ACCESSIBILITY AUDIT REPORT

MARINE DRIVE PROMENADE

NCPA TO MARINE DRIVE FLYOVER

DATE OF AUDIT: 22nd March 2021

1. Ramps and access ways to and from the promenade

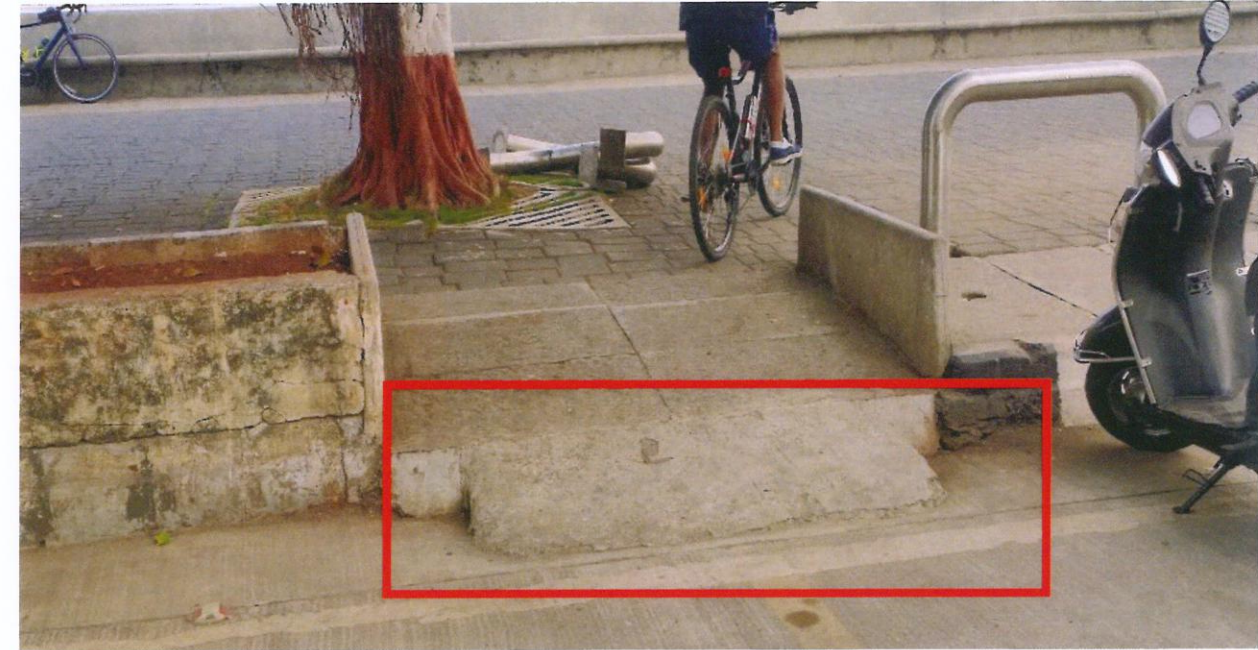
Kerb ramp present at the intersection has an efficient gradient but the road is at a higher level than the point at which the ramp starts. This makes a valley between the road and the promenade with a steeper slope from the end of ramp to the road making it difficult to negotiate.

The bollards placed at the center of the access way is the path of the wheelchair access.

Ramped accesses to the promenade are of an incorrect gradient.

2. Bus stops

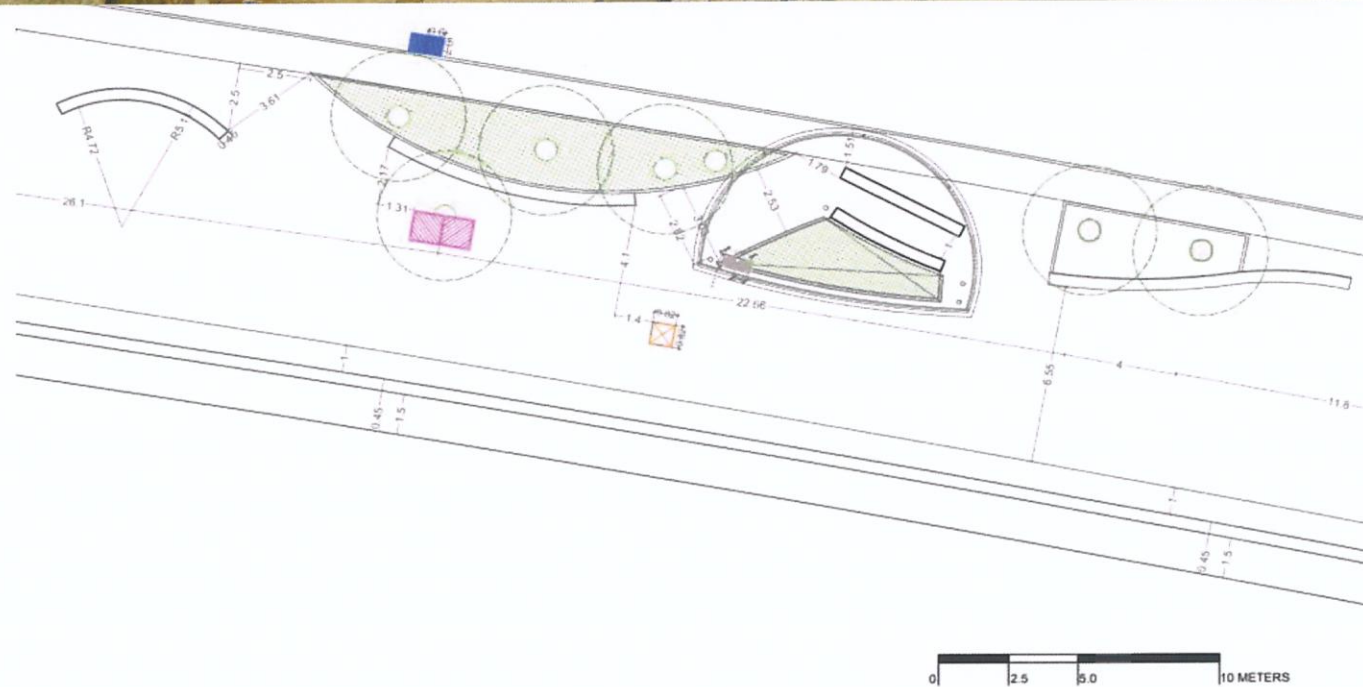
The road is at a lower level than the promenade and there is no ramped access to the road level from the bus stop for person to alight the bus. There is no dedicated wheelchair parking indicated at the bus stop.

The bus numbers are not readable and are not placed at an accessible height.

3. Newly installed bollards

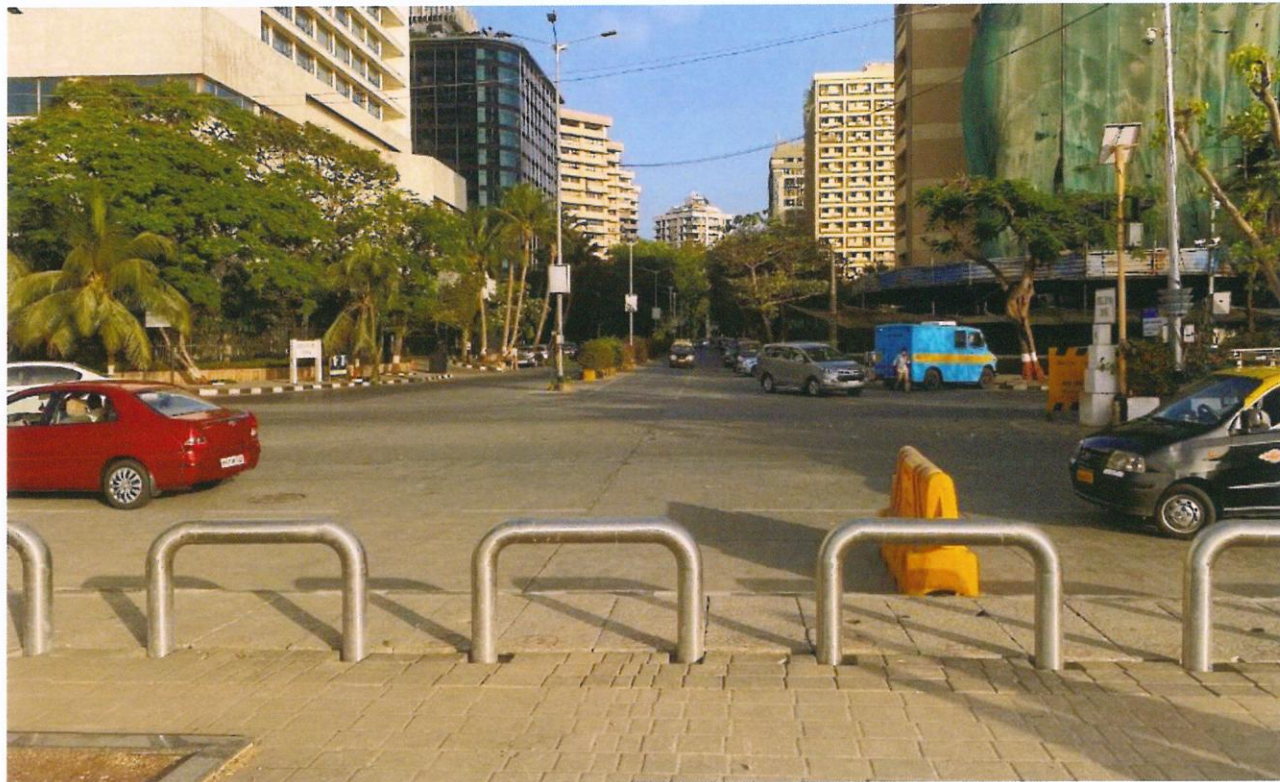
The newly installed bollards are 700 to 800 mm apart making them inaccessible for a wheelchair user. Minimum width required for a wheelchair to access a space is 900mm.

4. Tree gratings

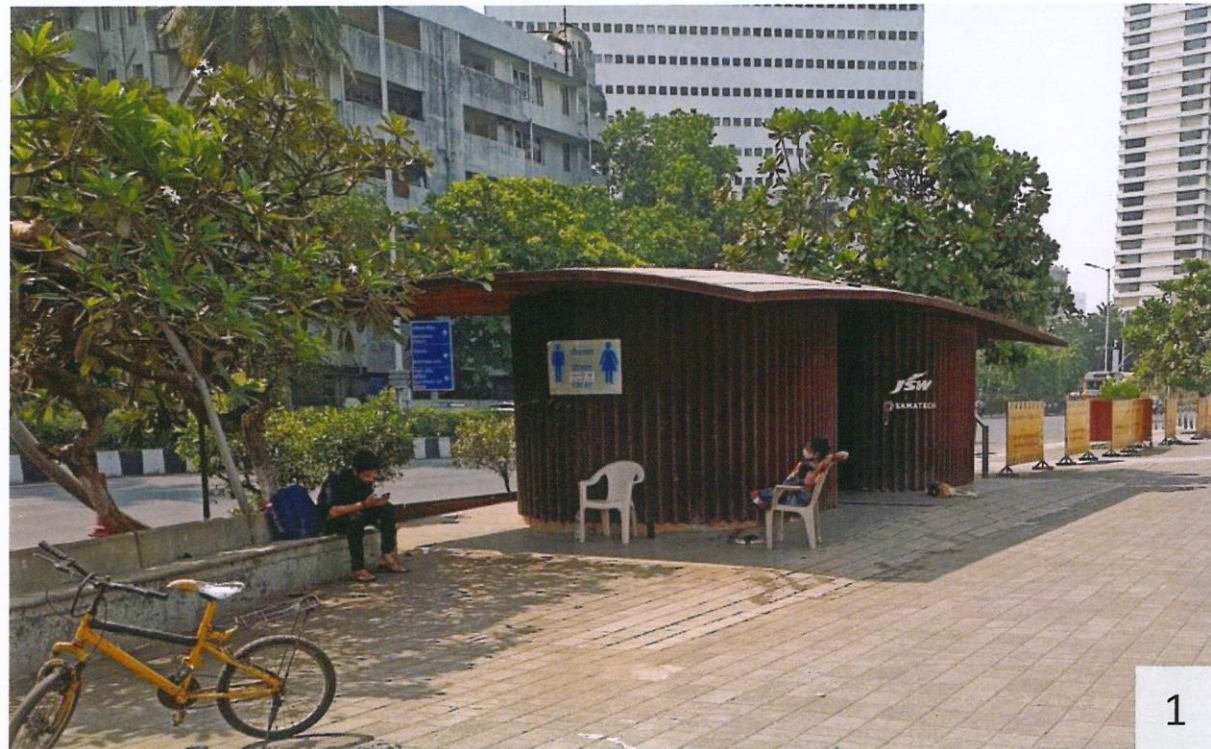
The growing roots of the trees resulting in broken grating and immediate paving. This creates an uneven surface making the area around the trees inaccessible for persons with disabilities.
